**OFFICIAL RESPONSE TO SIGNIFICANT ENVIRONMENTAL POINTS RAISED  
DURING THE TIMBER HARVESTING PLAN EVALUATION PROCESS**

**FROM THE DIRECTOR OF THE CALIFORNIA DEPARTMENT OF FORESTRY  
AND FIRE PROTECTION (CAL FIRE)**

TIMBER HARVESTING PLAN (THP) No:	1-21-00012-HUM
SUBMITTER:	Rolling Meadow Ranch INC
COUNTY:	Humboldt
END OF PUBLIC COMMENT PERIOD:	April 12, 2021
DATE OF RESPONSE AND APPROVAL:	June 10, 2021

Figure 1. A one-mile radius around the 2003 nest site. Project areas are shown in red and two locations are within the one-mile no disturbance buffer. Note: alternative nest sites may be closer to the Project.

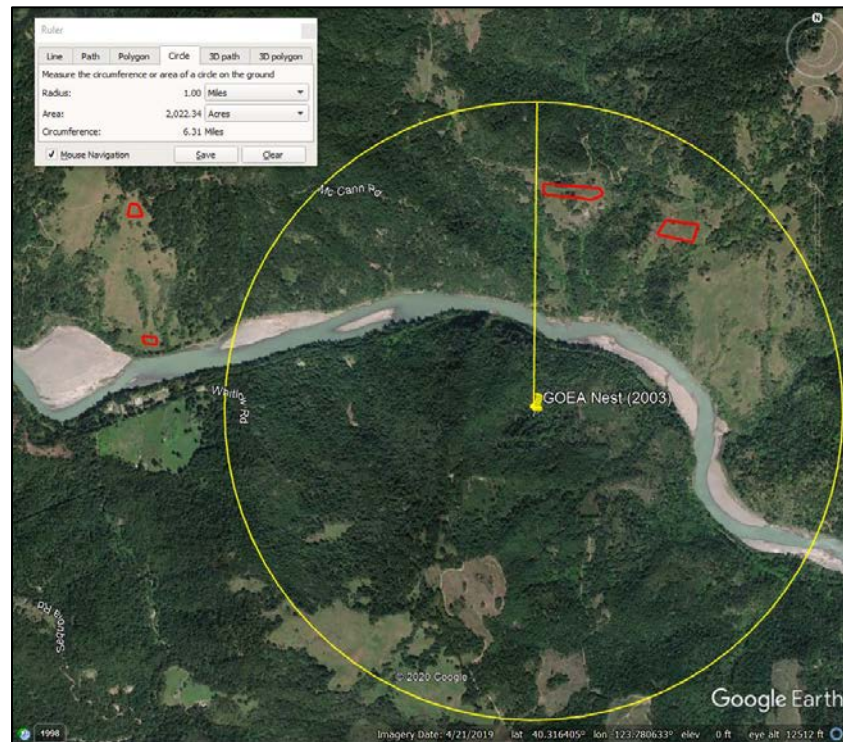
they are feeding nestlings (USFWS 2020). From the location of the documented 2003 nest site, the Project's two eastern most clusters of greenhouse facilities lie within one-mile and are within in line-of-site of the nest location (Figure 1- 2). The juxtaposition of the Project area to the 2003 nest site would maximize visual and other disturbances perceived at the nest site and potentially eliminate the majority of the foraging habitat within the core area (Figure 1 – 2).

Figure 3. Assuming no golden eagles forage within 1,000 meters of cultivation sites, the Project would result in a 57 percent reduction of foraging habitat within a one-mile no disturbance buffer.

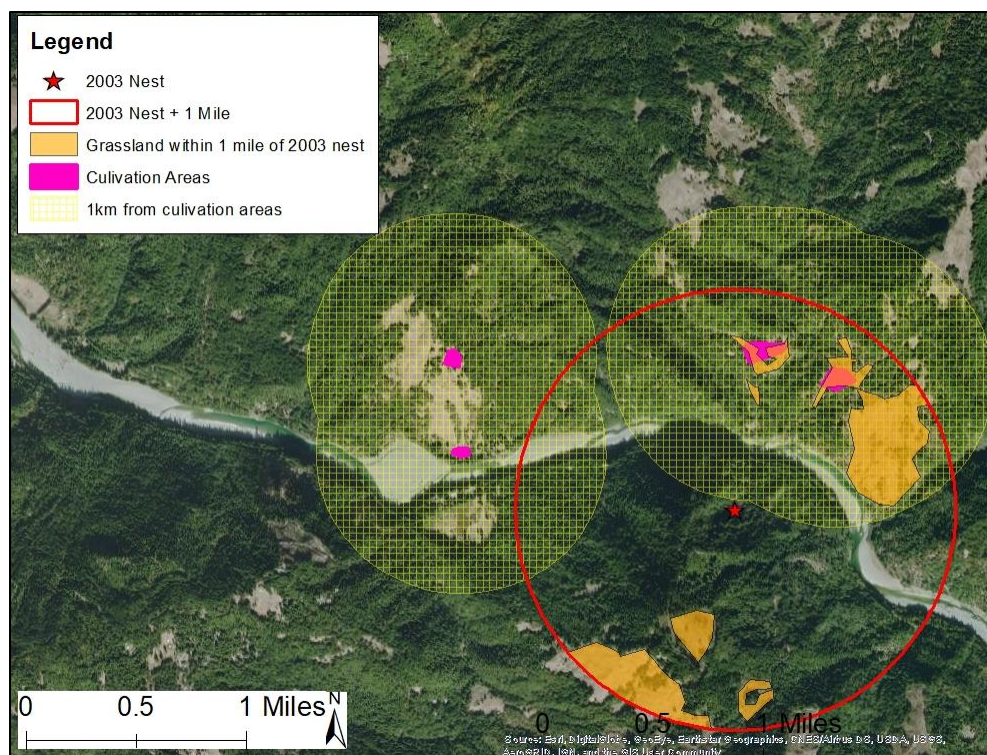
**Golden Eagle Sensitivity to Disturbance.** Although not well described in the Environmental Setting section of the IS/MND, the pre-Project baseline level of anthropogenic disturbance (e.g., visual, noise, and light) is very low or non-existent within the Project area. Any golden eagles in this vicinity are likely to be especially sensitive to human disturbance. Based on the range of disturbance distance thresholds for golden eagles (Hansen et al. 2017), they may flush from their nests or reduce feeding young with even low to moderate disturbance (including pedestrian activity) occurs within 1,000 meters (3,281 feet or 0.62 miles). Furthermore, nest-site protection is only beneficial if there is adequate access to prey. While male golden eagle's presence at nests is generally limited to prey delivery or brief assistance with young, they frequently rest on perches in view of nests (Watson et al. 2014). In southwestern Idaho, golden eagles perched away from nests were 12 times more likely to flush in response to recreationists than eagles at nests (Hansen et al. 2017). This suggests frequent human activity away from nests could result in chronic disturbance of foraging golden eagles and reduced provisioning rates at the nest. For example, if the 1,000-meter disturbance metric is applied to Project cultivation areas that may affect grassland foraging areas within a one-mile no disturbance buffer of the 2003 nest site, approximately 125 acres of 219 acres (57 percent) of foraging area may be avoided by foraging golden eagles attempting to feed their young (Figure 3).

Unlike short term disturbance impacts (e.g., timber harvest), ongoing chronic disturbance may warrant buffers in excess of 1,000 meters, further supporting the USFWS' one-mile no disturbance buffer for golden eagle nest sites. Importantly, the IS/MND Mitigation Measure Bio-16 calling for a 660-foot buffer from nest sites was intended by the USFWS for bald eagles (*Haliaeetus leucocephalus*) (USFWS 2017), who are much less sensitive to disturbance than golden eagles (USFWS 2016).
